Fermilab Coil Fabrication Status and Non-Conformity Report

9th HL-LHC Collaboration Meeting at Fermilab – 14-16 October 2019

QXFA109, quarantined

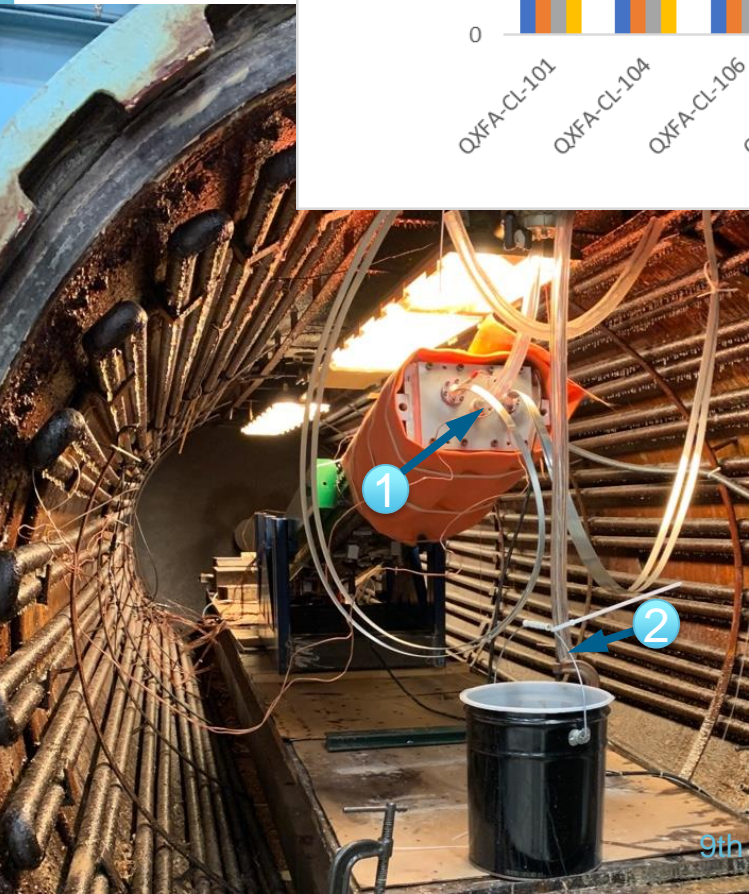
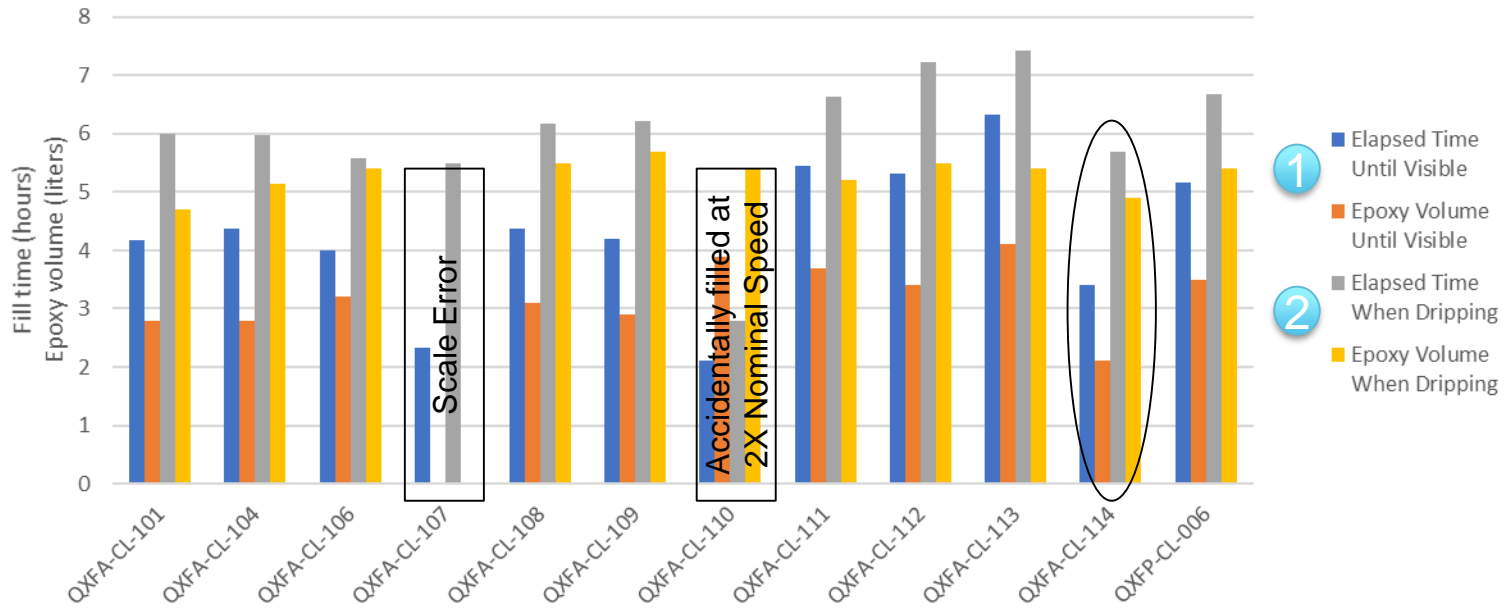
- All QXFA109 DR's closed → all issues resolved.
- Coil shipped to LBNL
- Incoming LBNL electrical measurements passed
- Inner layer RE saddle short to coil at coil assembly
- Coil quarantined and shipped to FNAL

QXFA114 Visual Inspection

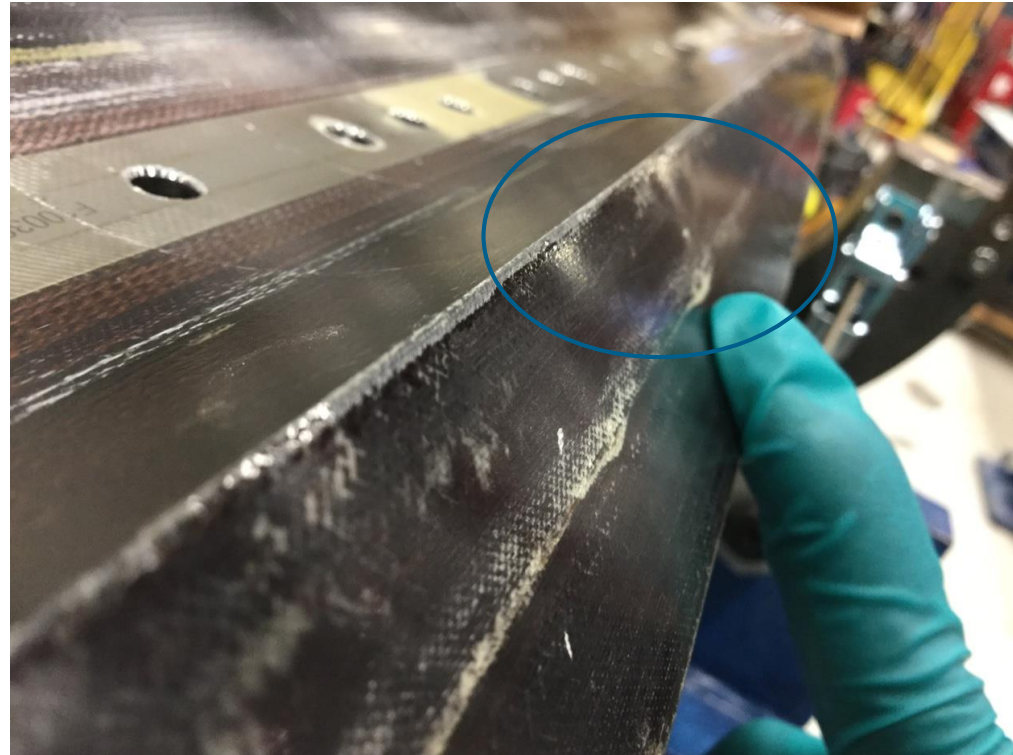
- Midplane G11 shim (125 μm) stuck to midplane shim SS tooling & delaminated from the coil in 2 places.

- Investigated coil midplane adhesion to tooling midplane
 - Performed test of several SS midplane/G11 mold released samples to investigate poor tooling release after impregnation.
 - Performed 10-stack mold release test.
 - ✓ Zyvax mold release and FNAL waxy mold release performed as expected.
 - Unable to identify cause of tooling adhesion after impregnation.
- All impregnation process steps & equipment have been checked and reviewed.
 - Traveler steps
 - Pumps, scales, T/C's
 - ✓ No abnormalities found.
- ✓ Coil CMM and Electrical Tests are normal.
- Coil epoxy defects on ID, severity unknown.
- G11 midplane insulator delamination appears to be minor.
- Final disposition of coil and DR #11754 is by G. Ambrosio.

QXFA114 Visual Inspection

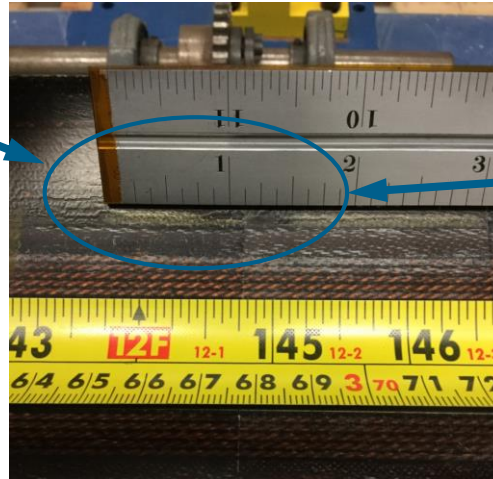
- Epoxy voids seen on ID of coil.

- One surface bubble on coil OD

QXFA114 Electrical Tests & CMM Measurements

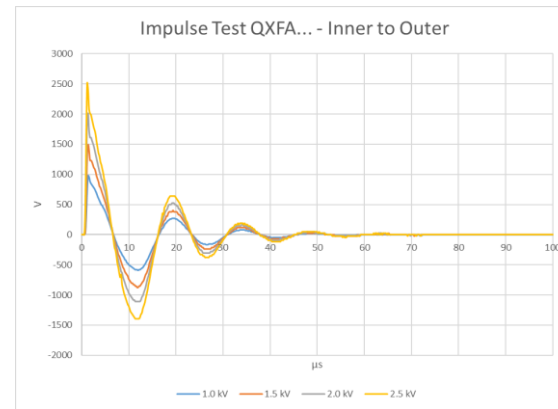
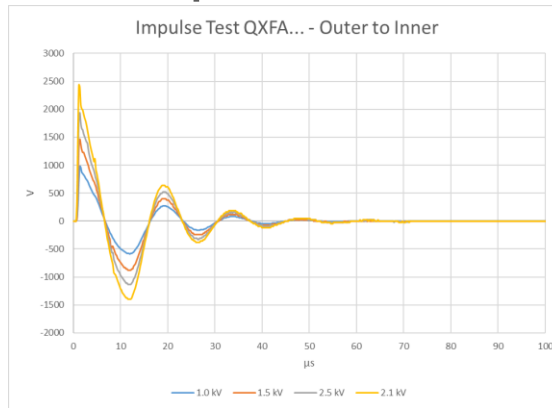
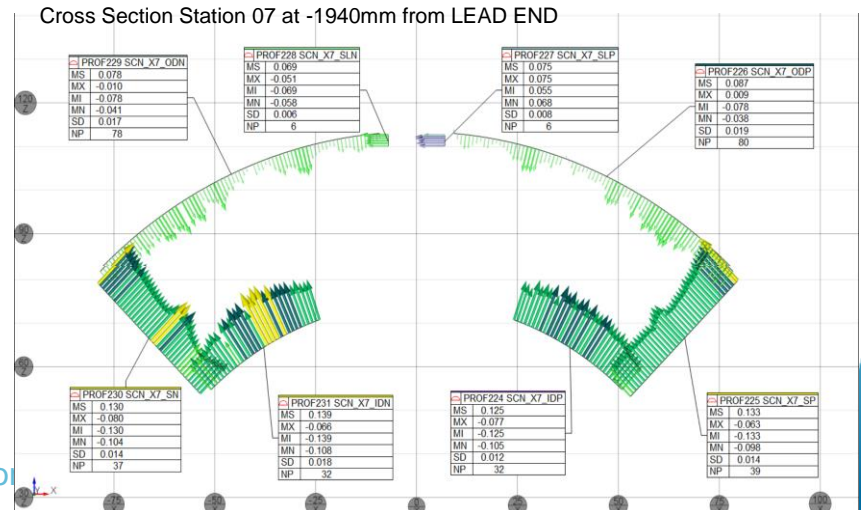
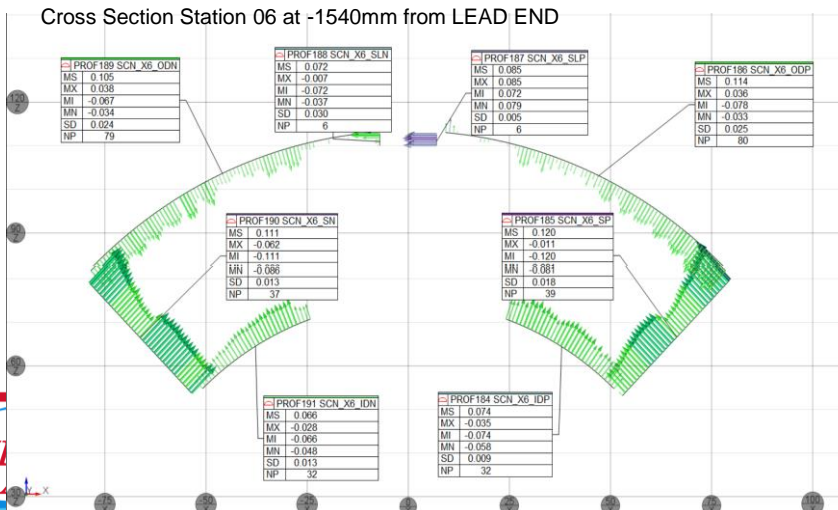
- All final electrical test performed and passed
 - VTB01 is open

- CMM results are typical.

DR-11869, QXFA115 Ridge Anomaly, Accepted

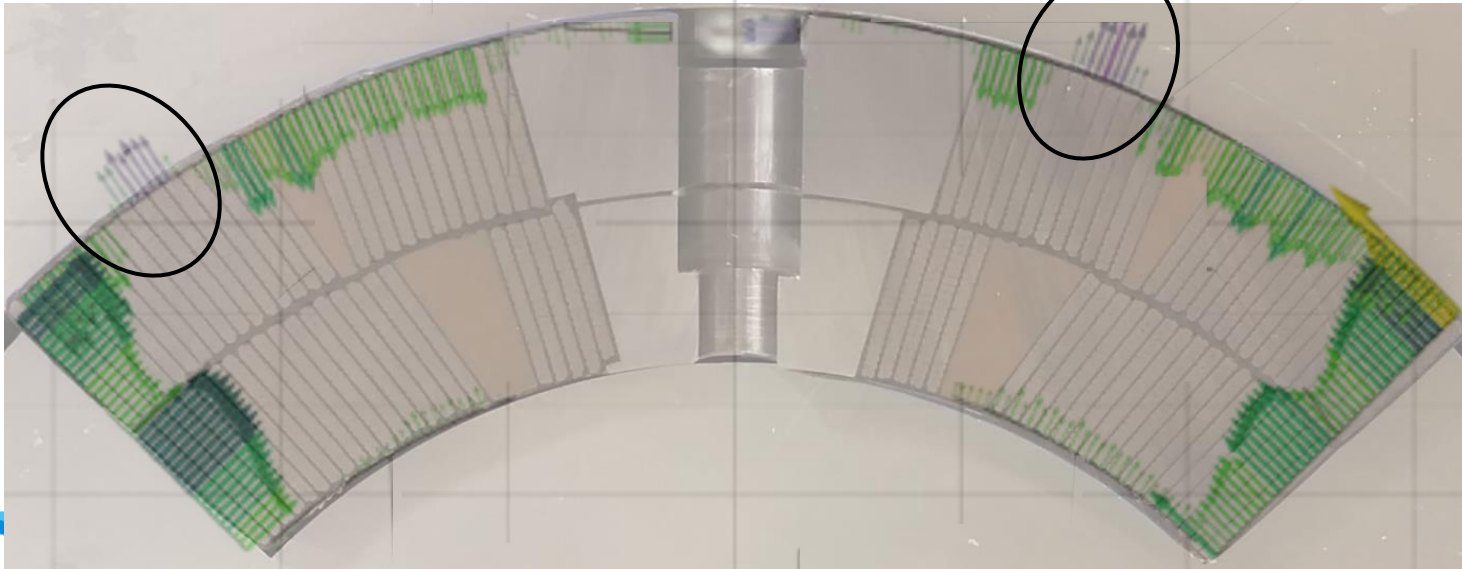
- QXFA115 CMM measurements indicate a bump on the coil about 0.09 mm above the coil outer surface that runs longitudinally about 2 m long and is about 5 turns wide on the transition side of the coil.
- A similar but smaller bump is on the coil about 0.05 mm above the coil outer surface that runs longitudinally about 3 m long and is about 5 turns wide on the non-transition side of the coil
- CMM is used to measure 14 discrete cross sections of the coil.
- Pressure sensitive film (Fuji film) used to characterize surface.

- Bump source is S2 glass delamination
- CMM probe pressure is very light
- No signal from Fuji pressure film
- Coil accepted & shipped to LBNL.

DR-11878, QXFA118 Roped Cable & Strand Damage, **Rejected**

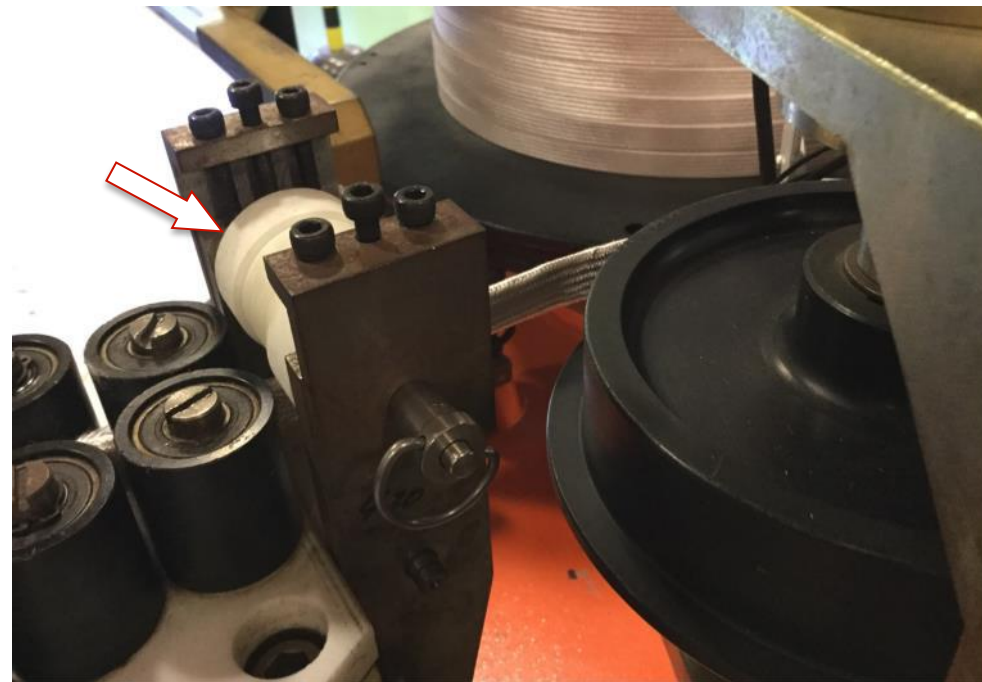
- On August 15, 2019 outer layer cable roped
 - 15th turn on the transition side (2 turns after wedge)
 - Due to hard way bend against the white roller.

- Obtained final disposition of coil QXFA118
 - Reviewed by conductor & cable folks
 - Dispositioned by Giorgio Ambrosio
- Back wound coil to retrieve all parts: wedges, pole pieces, end parts
- Adjusted boom to nominal position
- **Designed & procured taller rollers**, due end of Oct.
 - Mitigate strand damage
- **Boom position checked prior to each coil winding.**
- Coil QXFA119, inner layer completed on Selva.

QXFA118 Strand Damage

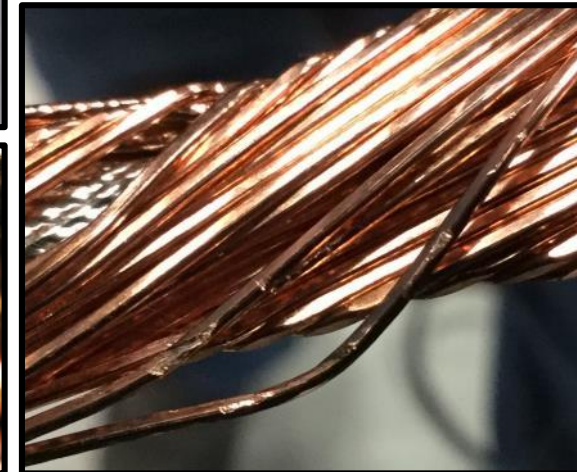
- Strand damage likely caused by the strand dragging against top edge of vertical guide roller(s) after the cable collapsed.

QXFA118 Roped Cable Cause

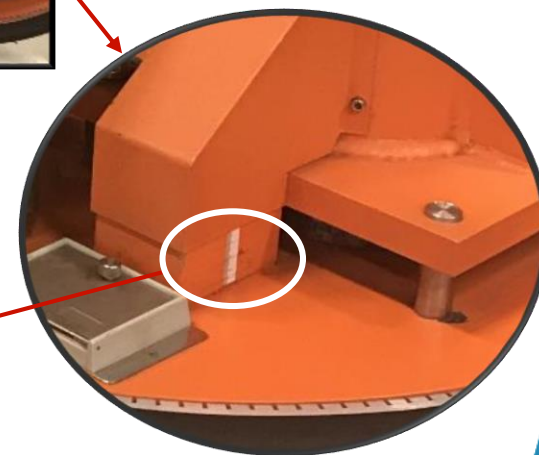
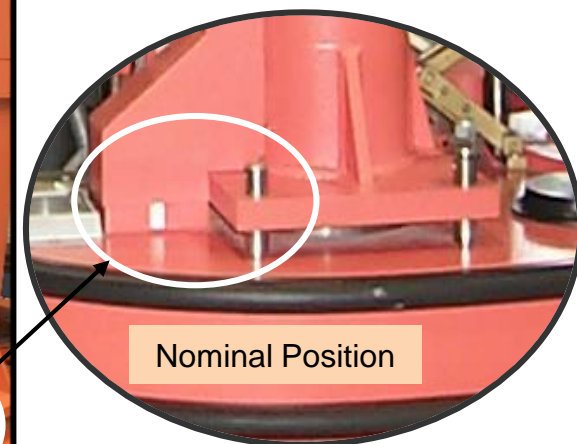
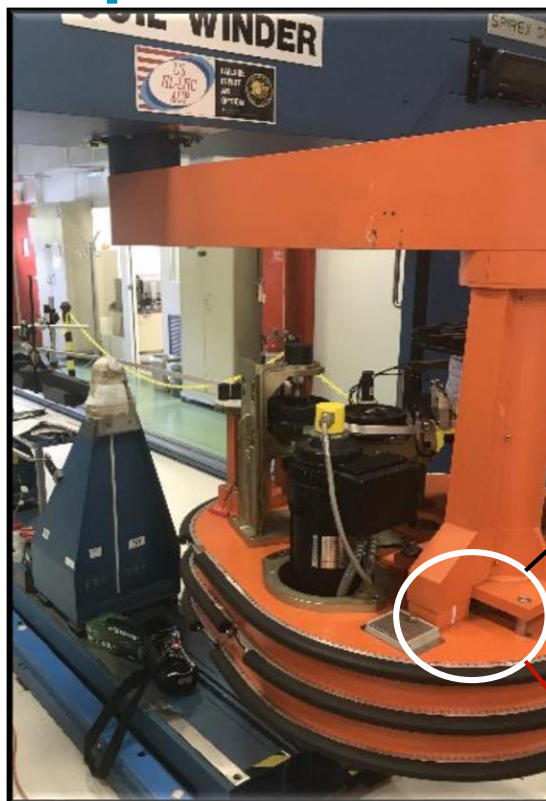
- The boom height has a 4 cm range set at 2.5 cm from the bottom and used for both inner and outer coil winding.
- Winding the inner layer had no adverse impact on the cable.
- During outer layer winding, the winding mandrel is higher than the boom causing upward pressure on the white roller and eventual cable collapse.
